R002 - DRAFT SEQUENCE - NOT INSTALLATION APPROVAL

Depth and sealing / review correction

02 / Check plumbing and factory adjustment

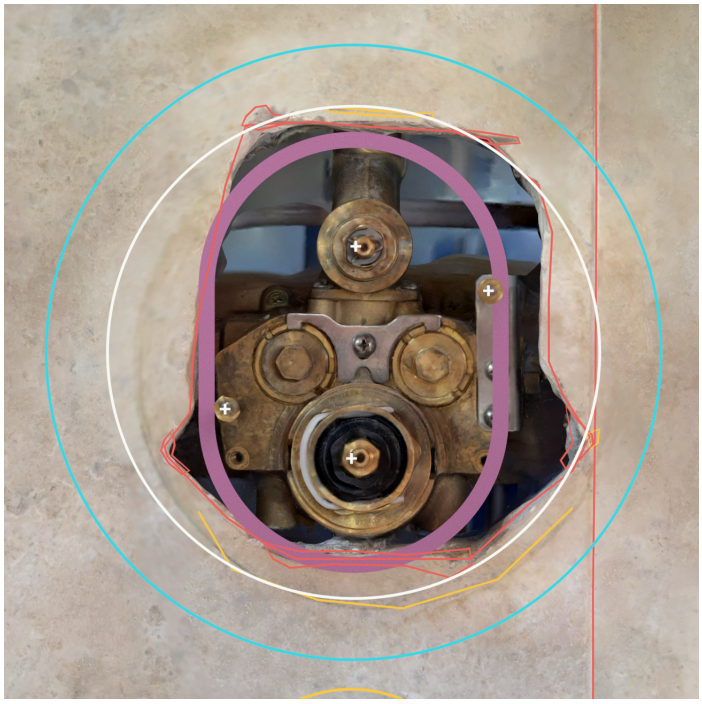
Trace reported rear stud contact with wood; verify valve rough-in depth and identify the stem adapters separately. Check available adjustment, final seating and supply/valve leakage before selecting a repair.

Do not shorten studs, force trim, or loosen pressure-containing parts for a homeowner measurement. No valve relocation target is approved.

05 / Install only the released material detail

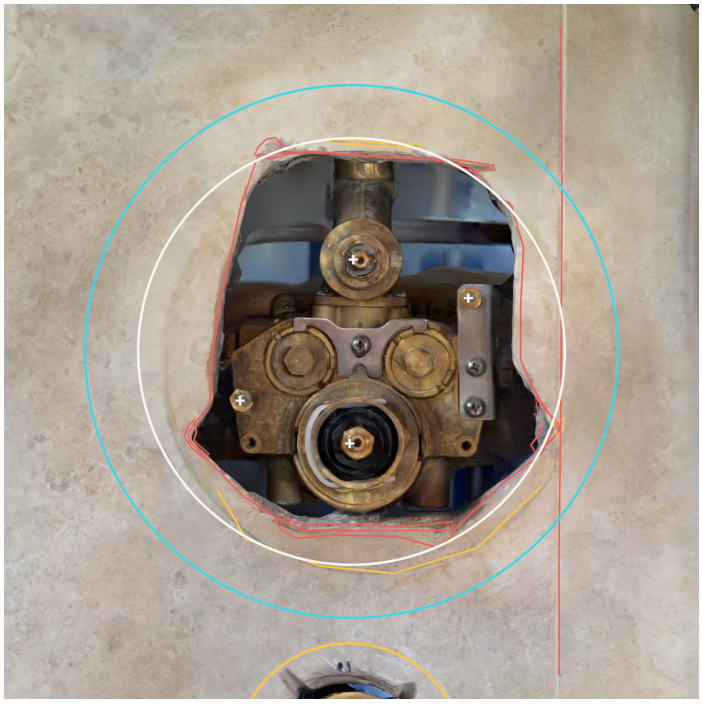
The current seated-cover trial has solid intersections and is rejected. No selected mortar, backing, sealant, finish or cure schedule exists. Do not install from this draft.

Control depth / diagnostic follow-up

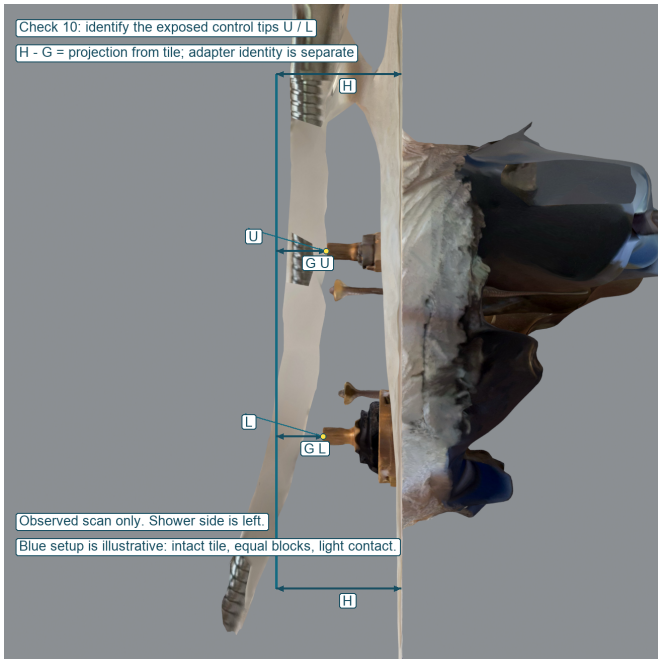
The user confirms excessive stud projection and reports rear bolt contact with wood. Trim studs thread into the valve; they do not need wood anchorage. Identify the same rear fasteners, framing/blocking and usable travel before selecting a remedy.

K-2973-KS specification p3: the labeled upper bare-tip and finished-wall dimensions imply a nominal upper-tip interval -6.3 to 27.0 mm from tile. Current comparison: 32.0 mm (conditional scan tip; identity and physical scale unverified). This is outside nominal interval if same bare tip. It is not a valve-relocation target.

Check 10 identifies the as-found tips/adapters and records block height H and both underside-to-tip gaps. H - G gives signed projection. The installer separately checks the plaster guard or documented axis datum. The 7/16-inch trim-stud limit does not apply to control stems.

Correct adapter and screw lengths must permit handle engagement and full cover/bonnet seating. An added backing plate changes that relationship again. Internal valve seals contain supply water; improper trim seating concerns external shower-water entry. Test these separately after the complete assembly is resolved.
